Reference: Entry Foyer Accessibility Review – Access Report
Development Application

ACCESS REPORT DEVELOPMENT APPLICATION

Project: Sydney Opera House
Eastern Offices
Document Type: Access Report – Development Application
Report Number: IAC-333

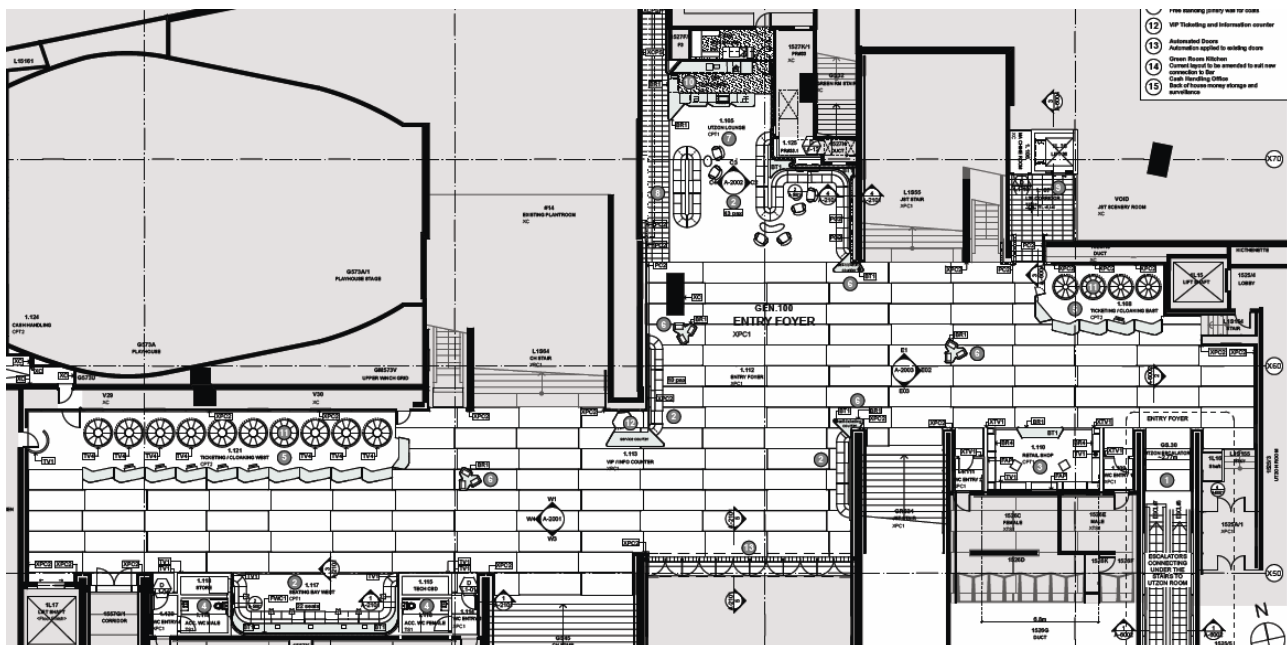
The area of the entry foyer is identified by the toned area in the plan below.

The main access related issues relate to the following issues:

- Access from the concourse under the stairs to the foyer
- Access to ticketing and ticketing office
- Access to WC facilities
- Access to concessions located in the Foyer
- Access to cloaking facilities
- Access to vertical transport to access the southern foyers
- Wayfinding and signage
- Lighting levels

The scope of these works is defined by the figure above. The following areas are specifically excluded from the scope and consideration of this report:

- GS45 connecting to the area under the stairs
- GRS31 connecting to the area under the stairs
- L1S64 connecting the Foyer with the Southern Foyer of the Concert Hall
- The escalators connecting to the Southern Foyers of the Concert Hall and the Joan Sutherland Theatre
- L1S155 & L1S154 stairs to the Utzon Room

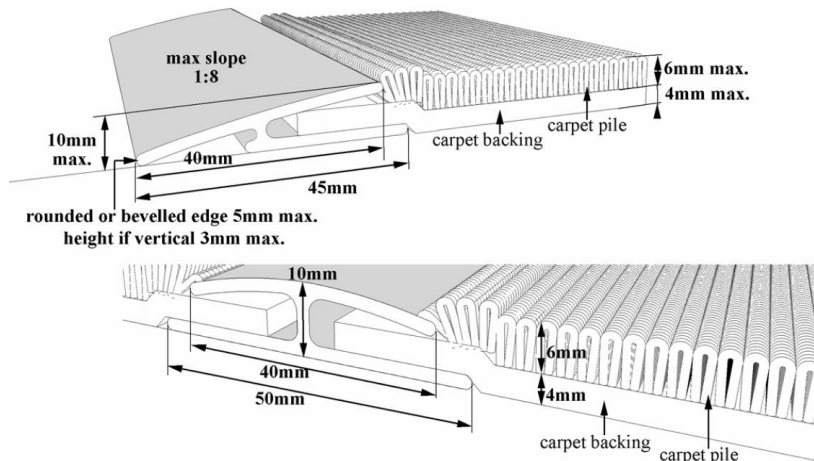
An appropriate wayfinding system to navigate the foyer zones will need to be developed. The resultant solution may include audio as well as braille tactile information.

Wayfinding details have yet to be developed.
